City of Portland, Maine - B	uilding or Use	Permit Applicat	tion P	ermit No:	Issue Date:	CBL:		
389 Congress Street, 04101 Tel				09-0996		013 K0	52001	
Location of Construction:	Owner Name:		Own	er Address:		Phone:		
28 NORTH ST	CAROLAN JO	OHN D	28 1	NORTH ST				
Business Name: Contractor Name		e:	Cont	tractor Address:		Phone		
	Portland Reno	ovations	111	Anderson Stre	et Portland	20771235	2077123590	
Lessee/Buyer's Name Phone:			Per p	nit Type: 1427 / S Iditions - Multi	Family		Zone: R-b	
Past Use:	Proposed Use:		Pern	nit Fee:	Cost of Work:	CEO District:	7	
3 Unit Residential	3 Unit Resider	ntial - remove existi	ng	\$270.00	\$25,000.00	0 1		
		nterior walls & tos siding demo others	FIRE DEPT: Approved INSPE		PECTION: Group: RZ	Type: 52		
lesalus	r - 3d.v.		*	See Cond	itions	TB(-70	BC-2003 ature: MB10/13/0	
Proposed Project Description: remove existing gable roof & inter histor than existing.	PE		PEDESTRIAN ACTIVITIES DISTRICT (P.A		nature: MBU T (P.A.D.) d w/Conditions	AŭD.) / /

#### Ann Machado - RE: 28 North Street

#### Jeanie Bourke - 28 North Street Residence

28 North Street Residence

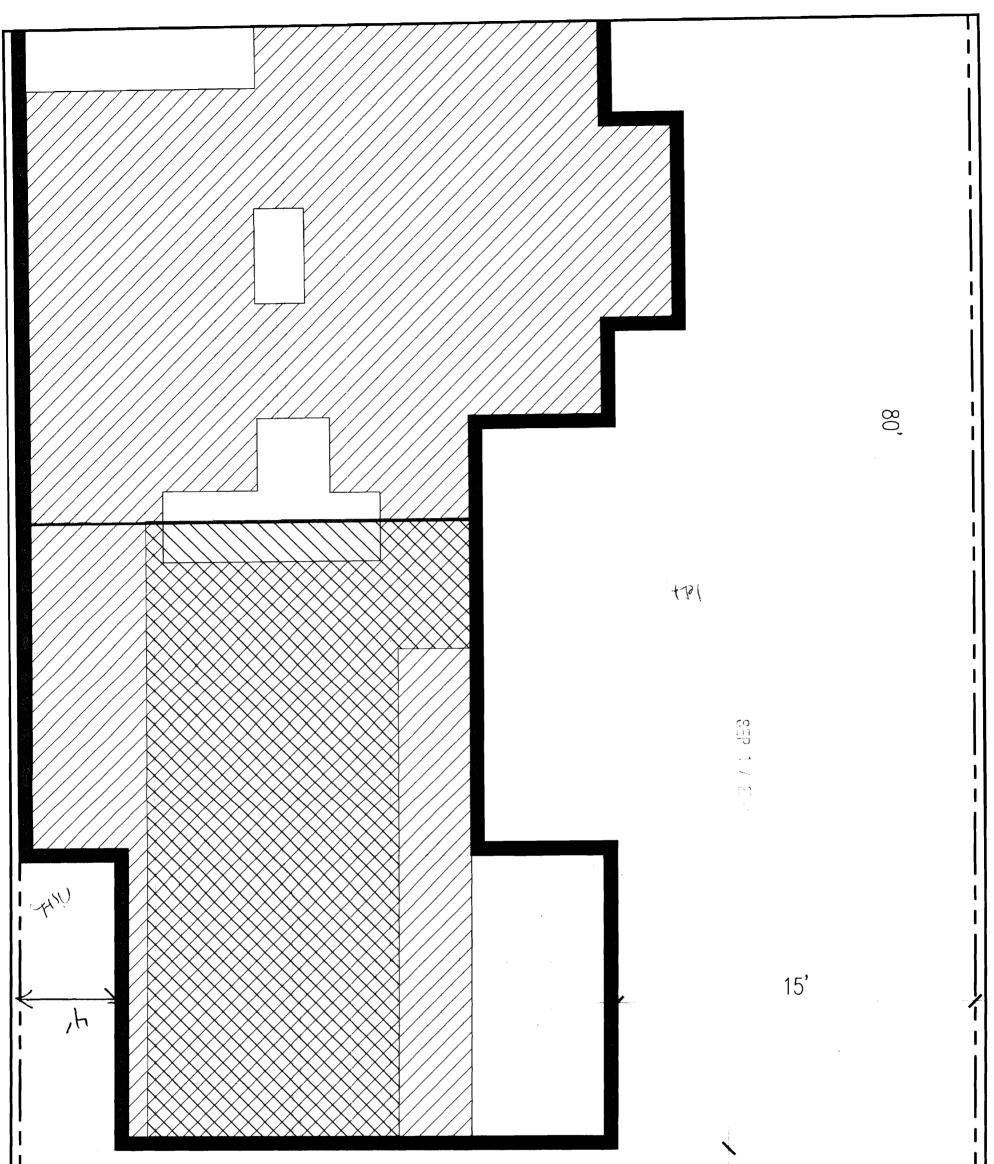
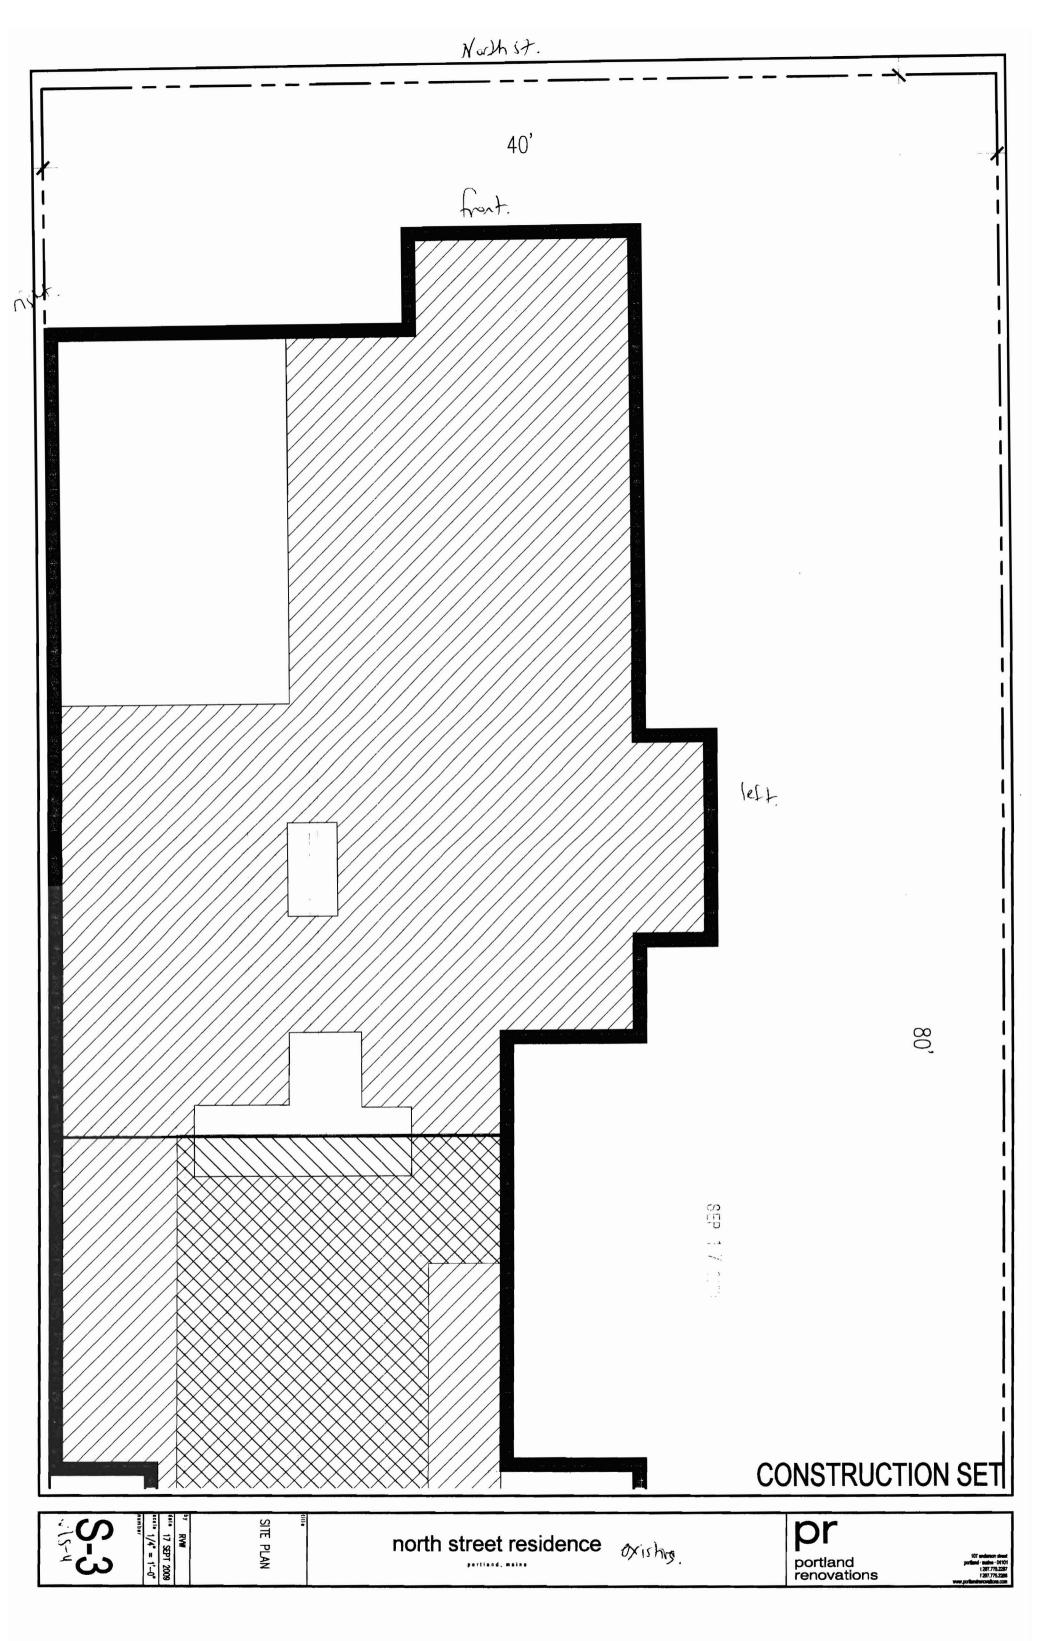
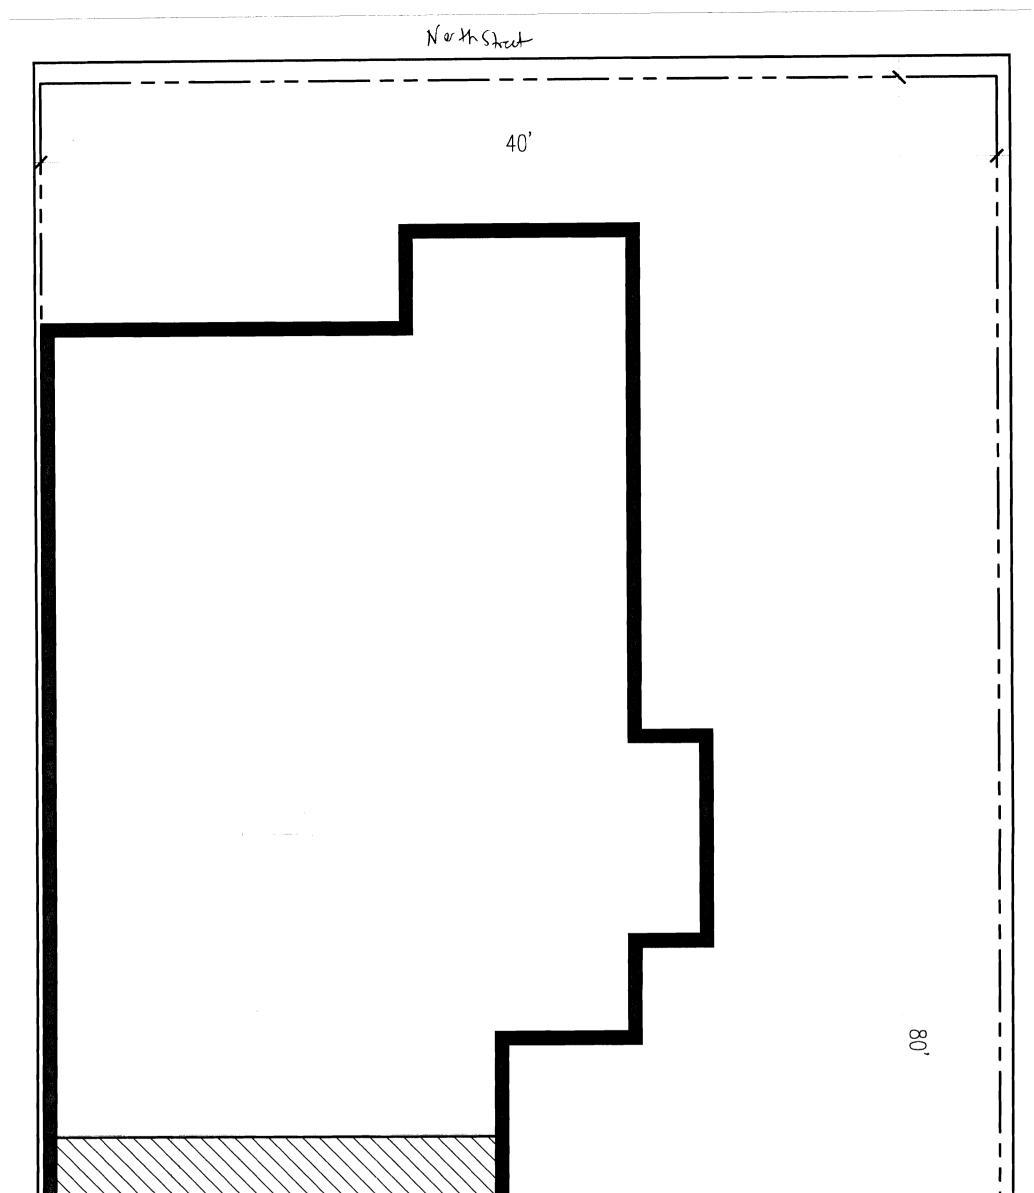
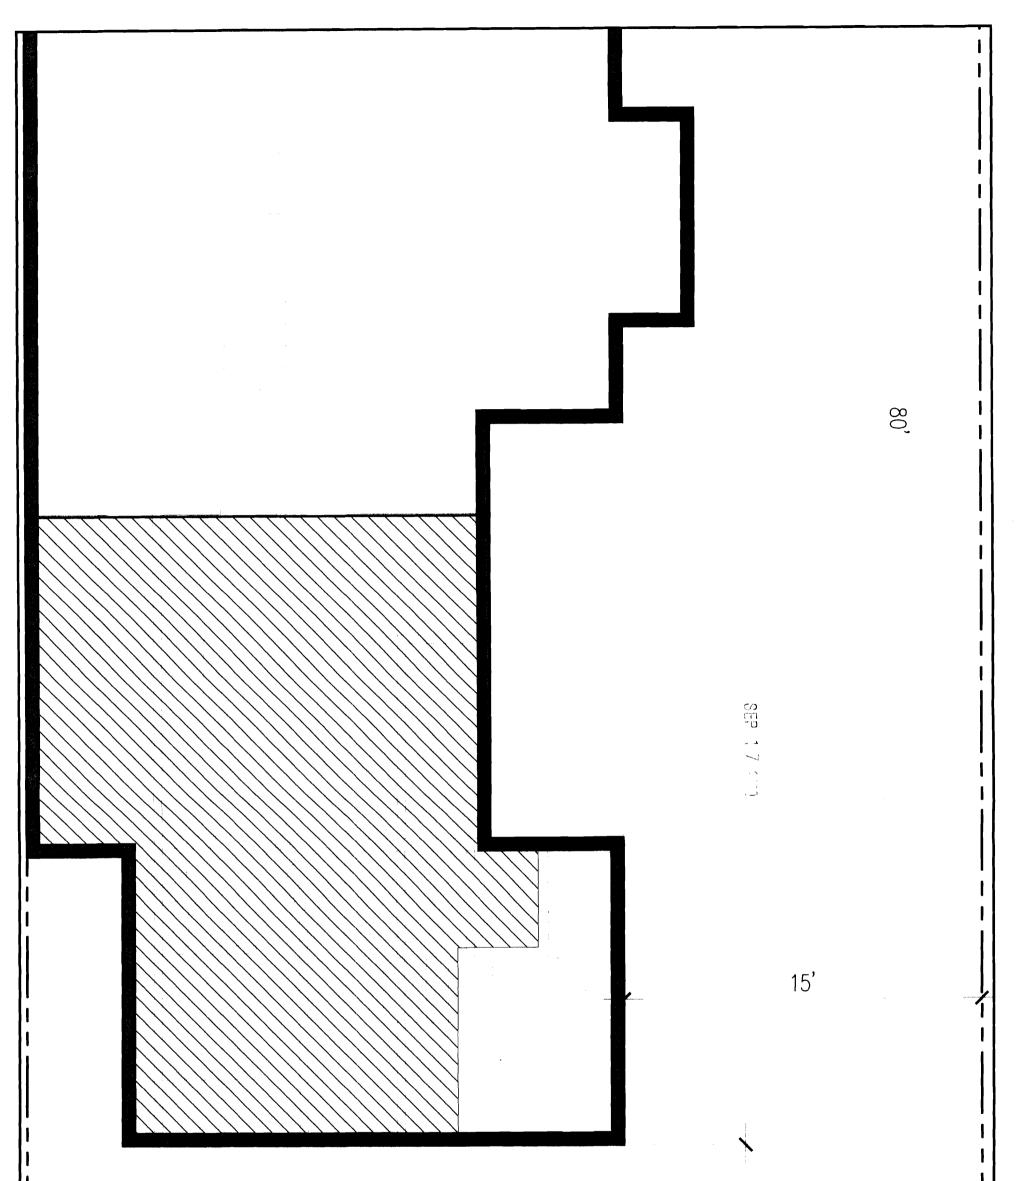
9/15/2009-amachado: Spoke to Bob at Portland Renovations. Need a plot plan. If the setbacks can't be met, then have to use section 14-436(b). Proposed new roof does not meet the criteria of tis section. The space is supposed to be created by "raising the existing roof configuration the minimum amount required to creat an additional stroy of habitable space..." This original submittal changed the roof configuration completely.

I need a plot plan that shows the location of the building and the setbacks.

Since it does not appear that the current building meets the setbacks, to increase living space in the top floor, you need to use section 14-436b) of the ordinance. "The floor area of the expansion shall be limited to no more than eighty percent of the first floor footprint. The additional floor area shall be created by raising the existing roof configuration the minimum amount required to create an additional story of habitable space, or by the use of dormers, turrets or similar structures."

9/17/2009-amachado: Received revised plans that meet section 14-436(b).
